**UNITED STATES
NUCLEAR REGULATORY COMMISSION**
WASHINGTON, D.C. 20555-0001

SUBJECT: COLUMBIA GENERATING STATION - STAFF ASSESSMENT OF
INFORMATION PROVIDED UNDER TITLE 10 OF THE *CODE OF FEDERAL
REGULATIONS* PART 50, SECTION 50.54(f), SEISMIC HAZARD
REEVALUATIONS FOR RECOMMENDATION 2.1 OF THE NEAR-TERM TASK
FORCE REVIEW OF INSIGHTS FROM THE FUKUSHIMA DAI-ICHI ACCIDENT
(CAC NO. MF5274)

STAFF ASSESSMENT BY THE OFFICE OF NUCLEAR REACTOR REGULATION

COLUMBIA GENERATING STATION

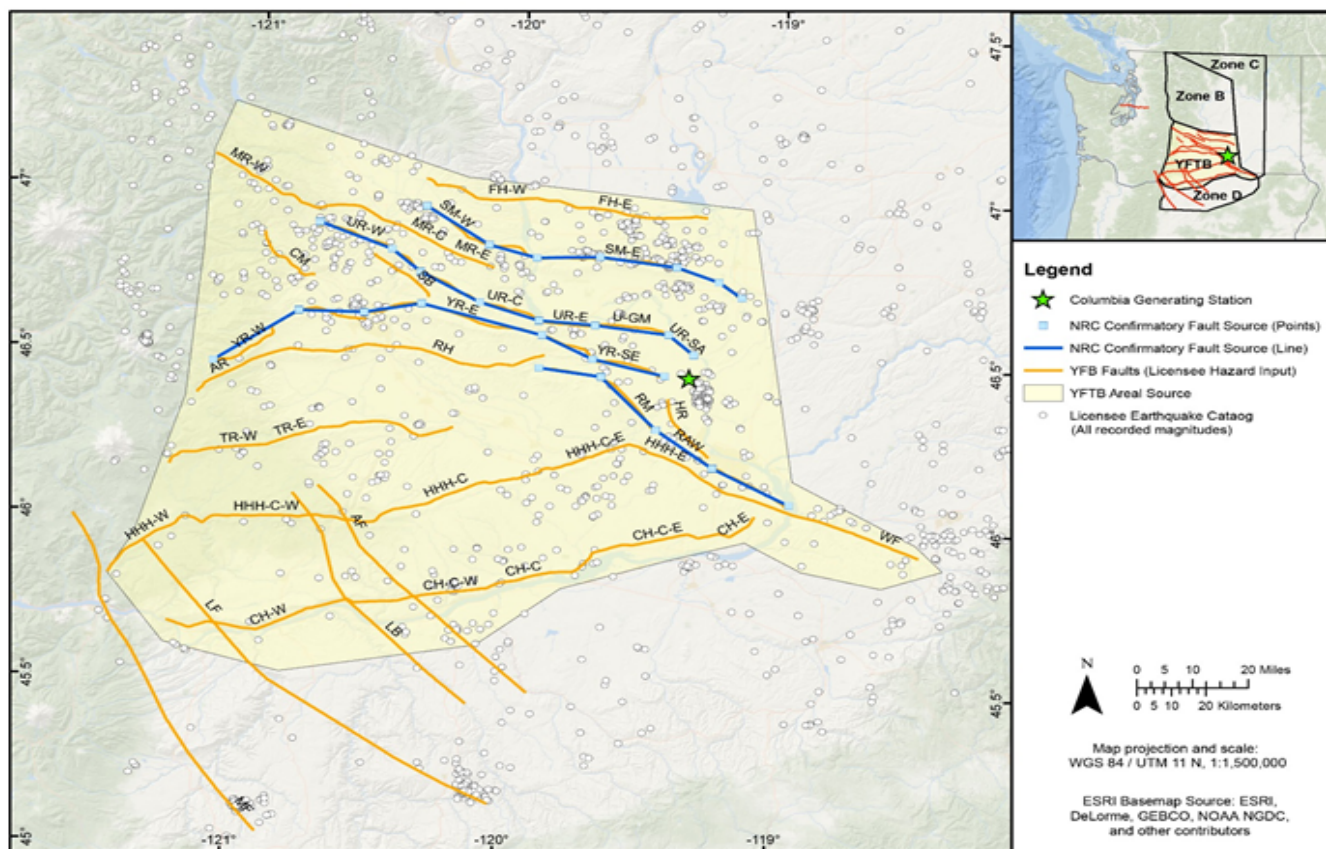
The TI Team identified twenty Quaternary fault sources as having the potential to contribute to the seismic hazard at the Hanford site. Nineteen of these are part of the YFTB faults (Figure 3.1-3 of this staff assessment). The 20th is the Seattle fault, which is located more than 200 km west of the Hanford site in the Puget Lowlands. It is a well-characterized Quaternary fault and is assessed as having the highest slip rate of all the faults in the Puget Lowlands (JBA et al., 2012). Sensitivity analyses conducted by the TI Team showed that the Seattle fault does not contribute significantly to the hazard because it is so distant from the site. The TI Team included the Seattle fault in their analysis, using the characterization from JBA et al. (2012), to document the limited contribution these Puget Lowland faults make to the hazard and to justify their decision to exclude the other faults from the Puget Lowlands from the Hanford PSHA.

The TI Team characterized 19 fault sources associated with the YFTB as well as the Seattle fault in the SSC model (see Figure 3.1-3 of this staff assessment). For each of the individual fault sources, the TI Team modeled the faults as a series of straight-line segments, allowing future earthquake ruptures to potentially occur on one or more of the segments. For the YFTB faults, the TI Team determined that the Rattlesnake Mountain, Umtanum Ridge, Horse Heaven Hill, and Yakima Ridge faults are the main contributors to the total hazard for 10 Hz at an annual frequency of exceedance level of 10^{-4} . The TI Team also included the Seattle fault in the SSC model; however, due to its low slip rate (about 1 mm/yr) and large distance from the Hanford site (200 km), the hazard contribution from this fault is small relative to other faults in the YFTB.

Figure 3.2-1. (a) Nine GMPEs for 1 (blue) and 10 (black) Hz spectral accelerations as a function of source-to-site rupture distance for an **M**6 earthquake. (b) The same nine GMPEs as a function of magnitude for a rupture distance of 20 km. Dashed red line is the CY14 backbone GMPE.

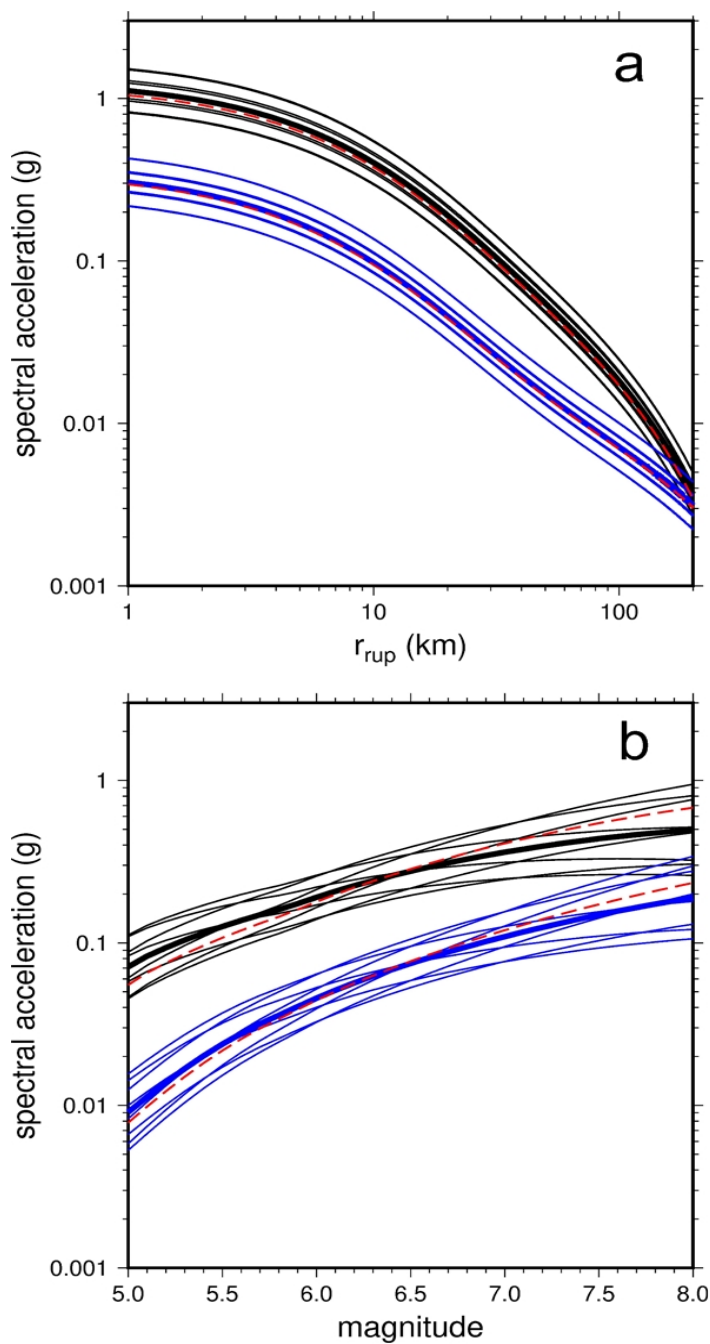
To evaluate the range of alternative magnitude and distance scaling as well as the distribution of median spectral accelerations predicted by the nine GMPEs, the NRC staff examined the behavior of the GMPEs for multiple earthquake magnitude and source-to-site distance combinations. Figure 3.2-1a of this staff assessment shows the nine GMPEs for 1 Hz (blue) and 10 Hz (black) spectral acceleration as a function of source-to-site rupture distance for an **M6** earthquake and Figure 3.2-1b shows the nine GMPEs as a function of magnitude for a rupture distance of 20 km. Figures 3.2-1a and b also show the CY14 backbone GMPE as a dashed red line. The staff also compared the nine GMPEs with the other three NGA-West 2 GMPEs used by the TI Team and notes that the nine GMPEs span a broader range of ground motions than the four input NGA-West2 GMPEs.

As demonstrated in Figure 3.2-1b, the staff notes that the nine GMPEs capture a range of alternative magnitude scaling models (i.e., crossing GMPEs) but, as shown in Figure 3.2-1a, only the distance scaling of the backbone CY14 GMPE. The NRC staff's evaluation of the backbone adjustment model found that the TI Team did develop alternative distance scaling but only for sites located on the hanging wall side of the fault and for source-to-site distances less

Figure 3.2-3. (a) NRC staff's alternative shear-wave velocity profiles for developing V_S -Kappa factors. (b) Comparison of V_S -Kappa factors when using alternative shear-wave velocity profiles for site amplification, based on NRC staff's confirmatory analyses.

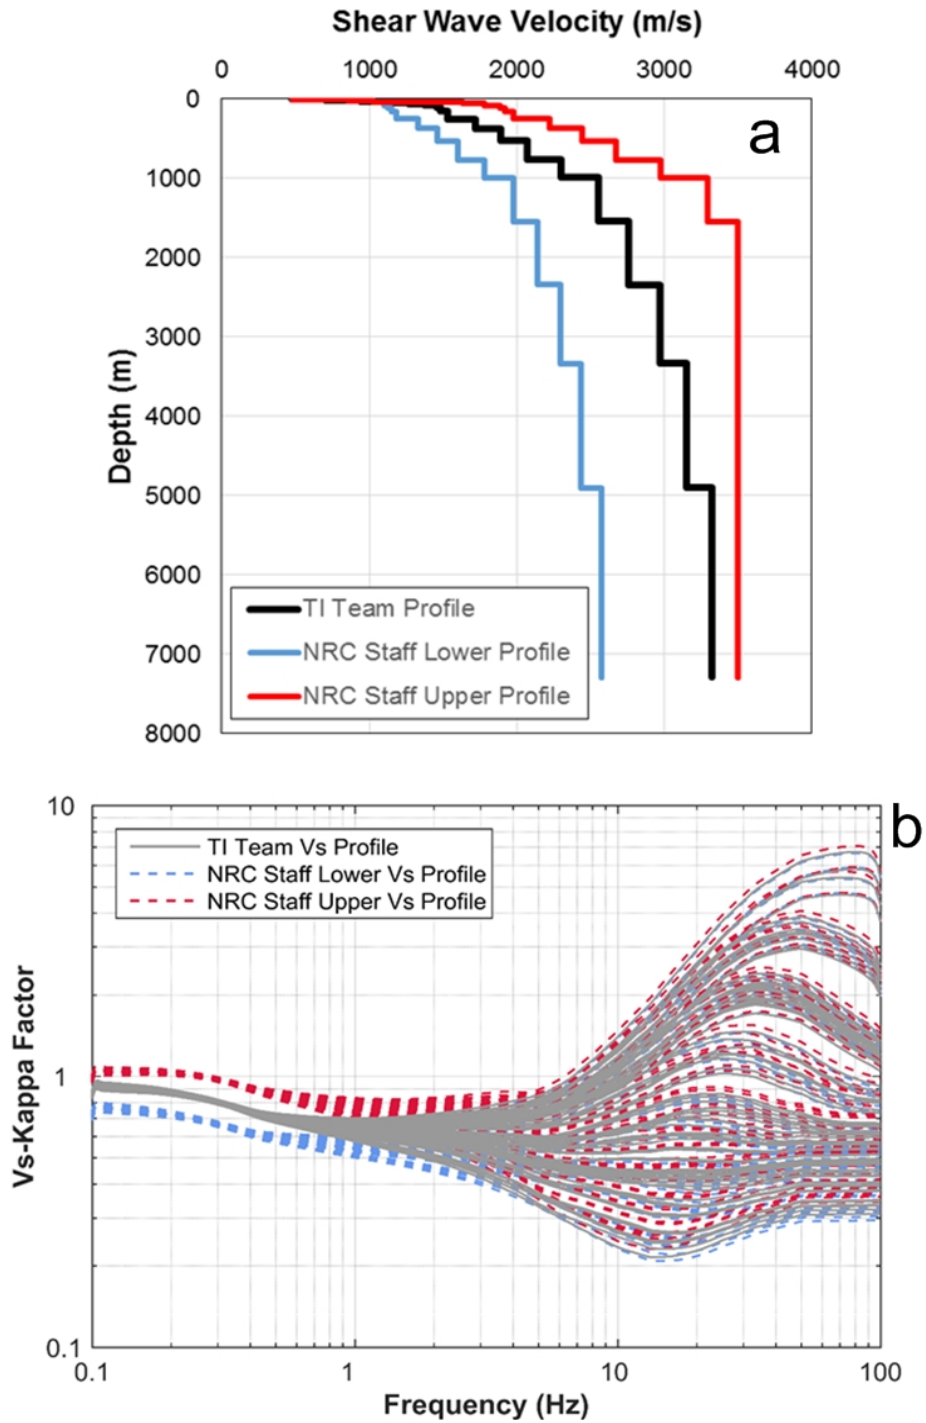
three host V_S profiles, which are shown in Figure 3.2-3a of this staff assessment. As shown in Figure 3.2-3b, the V_S -kappa adjustment factors using three host V_S profiles do not differ substantially from the V_S -kappa adjustment factors developed by the TI Team, which were developed using a single host V_S profile. The NRC staff's confirmatory analysis demonstrates that differences between the host and target kappa values have a much greater impact on the final V_S -kappa adjustment factors than impedance differences between the host and target V_S profiles.

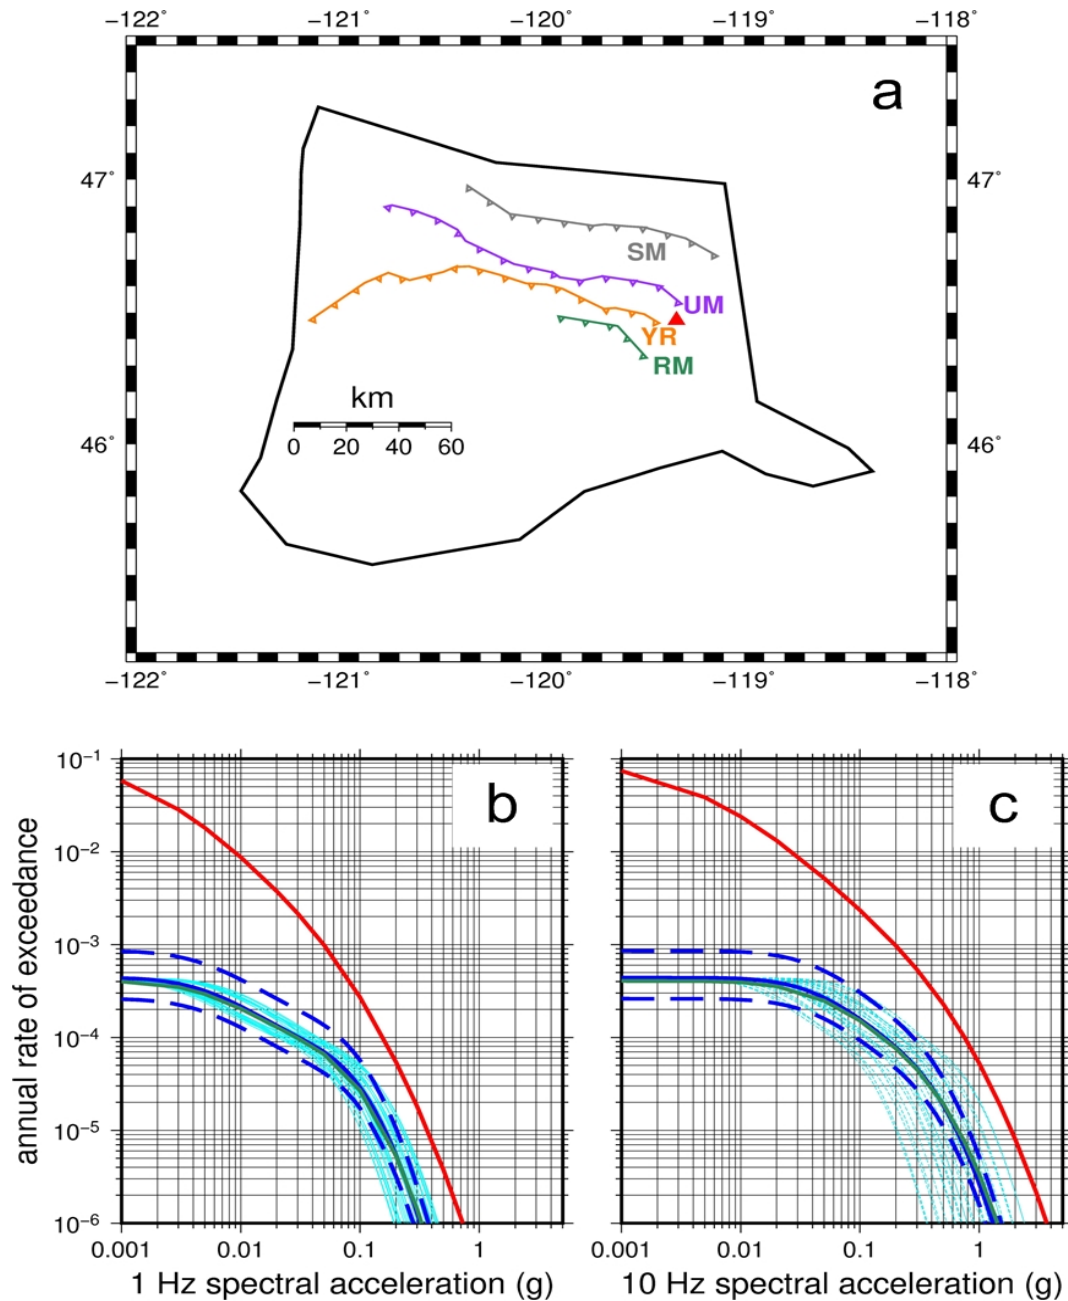
The YFTB fault sources selected by the staff for its confirmatory evaluation are the Rattlesnake Mountain, Yakima Ridge, Umtanum Ridge, and Saddle Mountain faults (Figure 3.3-1a of this staff assessment). For each of the fault sources, the staff evaluated a plausible range of slip rates. Figures 3.3-1(b-c) of this staff assessment show the staff's 1 Hz and 10 Hz hazard curves for the Rattlesnake Mountain fault. For its confirmatory evaluation, the staff used 27 of the 189 crustal earthquake GMPEs, each of which are shown in Figure 3.3-1(b-c). Also shown in Figures 3.3-1(b-c) are hazard curves resulting from using the 5th and 95th percentile slip rates for the Rattlesnake Mountain fault. As shown in Figures 3.3-1(b-c), the staff's confirmatory results closely match the licensee's results for both the 1 Hz and 10 Hz mean hazard curves. Using similar methods, the staff was able to confirm the reasonableness of the licensee's 1 Hz and 10 Hz hazard curves for the Yakima Ridge, Umtanum, and Saddle Mountain faults. The areal source selected by the staff for its confirmatory evaluation is the YFTB source zone, which as the host areal source zone contributes significantly to both the 1 Hz and 10 Hz total mean hazard for the CGS site. Similar to the TI Team's approach, the NRC staff assumed that the majority of the seismicity within the YFTB zone is not associated with YFTB faults. As such, the NRC staff developed a set of virtual faults to generate earthquakes that are not directly associated with known faults within the YFTB. Using the Hanks and Bakun magnitude-area scaling relationships (Hanks and Bakun, 2008), the staff derived the length for each of the virtual faults based on the median MMAX, faulting mechanism, dip angle, and seismogenic thickness as used in the logic tree for the YFTB zone. For each of the virtual faults in the YFTB zone, the staff calculated the hazard using a range of earthquake magnitudes from **M5** to the median maximum magnitude earthquake, which is **M6.8**. The staff developed a suite of seismic hazard curves for each of the virtual faults and then averaged the results to obtain mean 1 Hz and 10 Hz hazard curves for the YFTB source zone.

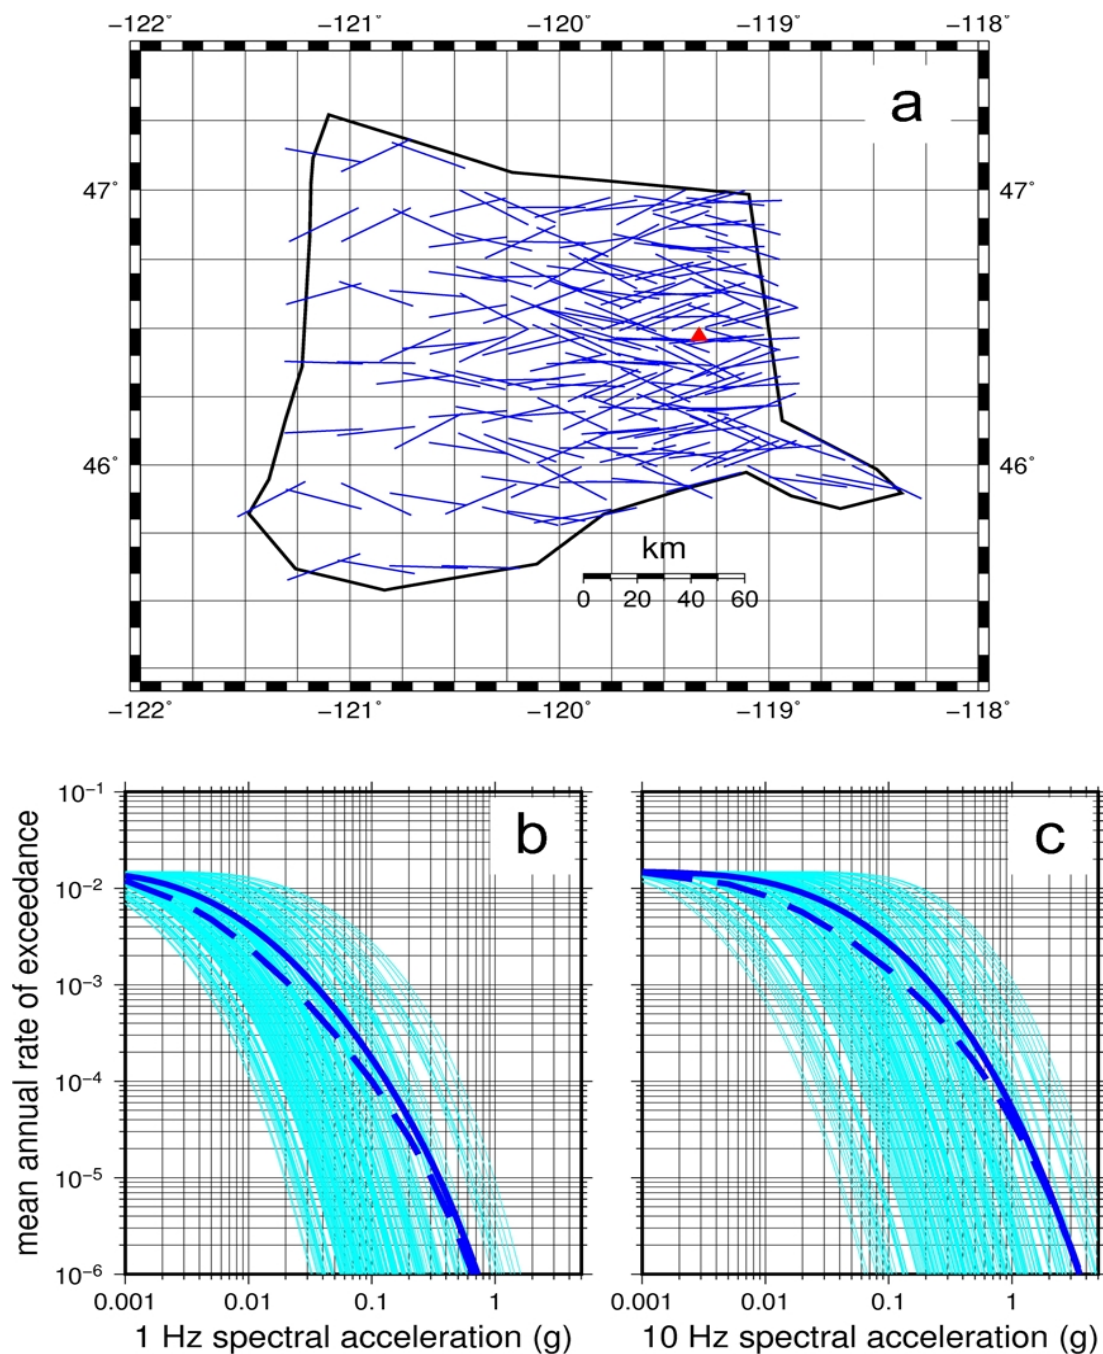
Figure 3.3-2(a) of this staff assessment shows the location of the virtual faults for the YFTB source zone. For its analysis, the staff placed virtual faults more densely around the CGS site and more sparsely at distances beyond 100 km from the site. The staff used this placement of virtual faults to adequately capture the range of significant source-to-site distances. Figure 3.3-2(a) shows the virtual faults for the reverse faulting mechanism, with each fault having a length of about 31 km and a down-dip width of about 20 km. To represent the predominant structural characteristics of the YFTB, the staff selected fault orientations randomly between N60°W and N120°W for the reverse-faulting mechanism. For the strike-slip and normal faulting mechanisms, the staff selected similar predominantly E-W fault orientations. Figures 3.3-2(b-c) of this staff assessment show the 1 Hz and 10 Hz hazard curves for each of the 324 YFTB virtual faults as well as the staff's and licensee's mean hazard curves. As shown in Figure 3.3-2(b-c), the staff's confirmatory results closely match the licensee's results for both the 1 Hz and 10 Hz mean hazard curves.

Figure 3.4-3. Comparison of licensee's and NRC staff's hazard curves at (a) 1 Hz spectral acceleration and (b) 100 Hz spectral acceleration.

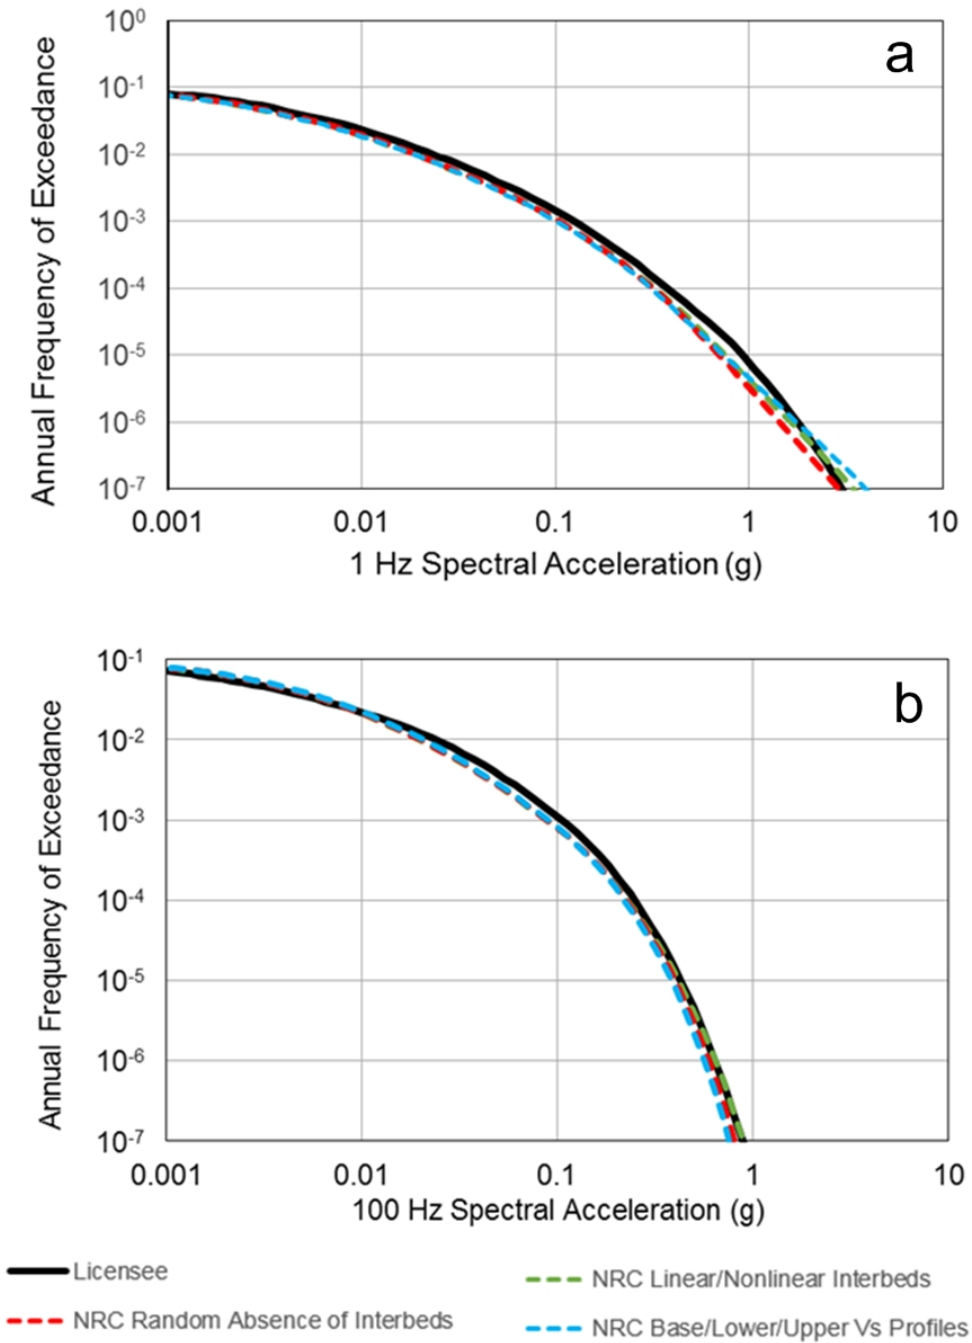
The NRC staff performed a confirmatory site response analyses to assess three different scenarios: (1) the effect of differing assumptions for the epistemic uncertainty and aleatory variability for the site base case V_s profiles; (2) the sensitivity of the site amplification factors to the thickness of the interbed layers within the Saddle Mountain Basalt; and (3) the licensee's use of the Darendeli shear modulus degradation and damping curves (Darendeli, 2001) for the sedimentary interbeds. To assess Scenario 1, the NRC staff developed three profiles for the upper 160 m using a log standard deviation of 0.25 to account for epistemic uncertainty in the subsurface properties, instead of using only a single base case V_s profile. Figure 3.4-1 of this staff assessment shows the NRC staff's middle, upper, and lower base case profiles along with the recorded V_s data in the upper 160 m. To evaluate the sensitivity of the site amplification factors to the thickness of the interbed layers within the Saddle Mountain Basalt (i.e., Scenario 2), the NRC staff performed its analysis by randomly removing a few of the interbed layers in the 60 randomized site profiles. To assess Scenario 3, the NRC staff also performed its site response analysis using either the Darendeli (2001) curves or by assuming a linear response for the interbeds. Figure 3.4-2 shows the staff's confirmatory analyses results for the three scenarios for both 1 Hz (a) and 100 Hz (b) median amplification factors and 1 Hz (c) and 100 Hz (d) log standard deviations. As shown in Figure 3.4-2, the impact of using multiple base case profiles, randomly varying the thickness of the interbeds, and assuming a linear response for the interbed layers, does not result in amplification factors that differ significantly from those developed by the licensee. Similarly, Figure 3.4-3 of this staff assessment shows that the 1 Hz
